RE: Happy Scenes Water System PWSID # CO0234390

PLAN REVIEW ADDENDUM

RE: Happy Scenes Water System PWSID # CO0234390
Engineering Design Report
Plan Review Addendum

Please find attached a Plan Review Addendum in response to your Comments to Plan Review, dated December 1, 2008.

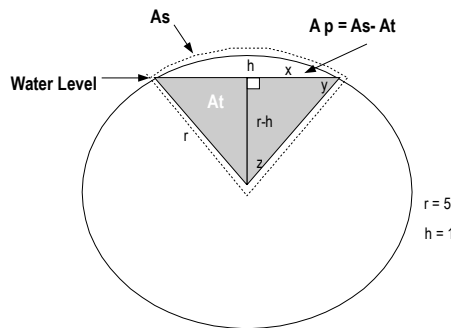
A sump pump will be used to drain the tank. It is not possible to install a drain in this underground tank. The drain line would not be able to daylight. The waste will be applied to the ground in the treatment plant easement.

The inlet to the storage tank is equipped with a spray bar for radon removal, as well as sodium hypochlorite mixing. The 1.25 inch diameter spray bar will be located 3 inches below the tank ceiling. The normal water level will be 7.75 inches below the bar, resulting in a water depth of 9 feet in the horizontal tank. The resulting volume is 14,237 gallons.

To find the volume of the oblong tank with the water level at 9 feet instead of at the full diameter of 10 feet, the area of the piece above the water level (A_p) was found by finding the area of the section of circle (A_s) and deducting the area of the triangle (A_t) from it. The volume, resulting from A_p , was then found and deducted from the full volume of 15,000 gallons. Please see the following calculations.

$$\underline{A_t = \frac{1}{2}bh(2),}$$

with $b = x$ and $h = (r-h)$, from the diagram above.

$$\begin{aligned}x &= \sqrt{2rh - h^2} \\x &= \sqrt{2 \cdot 5 \cdot 1 - 1^2} \\x &= 3\end{aligned}$$

$$\begin{aligned}A_t &= \frac{1}{2}(x)ft \cdot (r-h)ft \cdot (2) \\A_t &= \frac{1}{2}(3)ft \cdot (5-1)ft \cdot (2) \\A_t &= 12ft^2\end{aligned}$$

$$A_p = A_s - A_t$$
$$A_p = (16 - 12) ft^2$$
$$A_p = 4 ft^2$$

$$15,000 gal - 763 gal = 14,237 gal$$
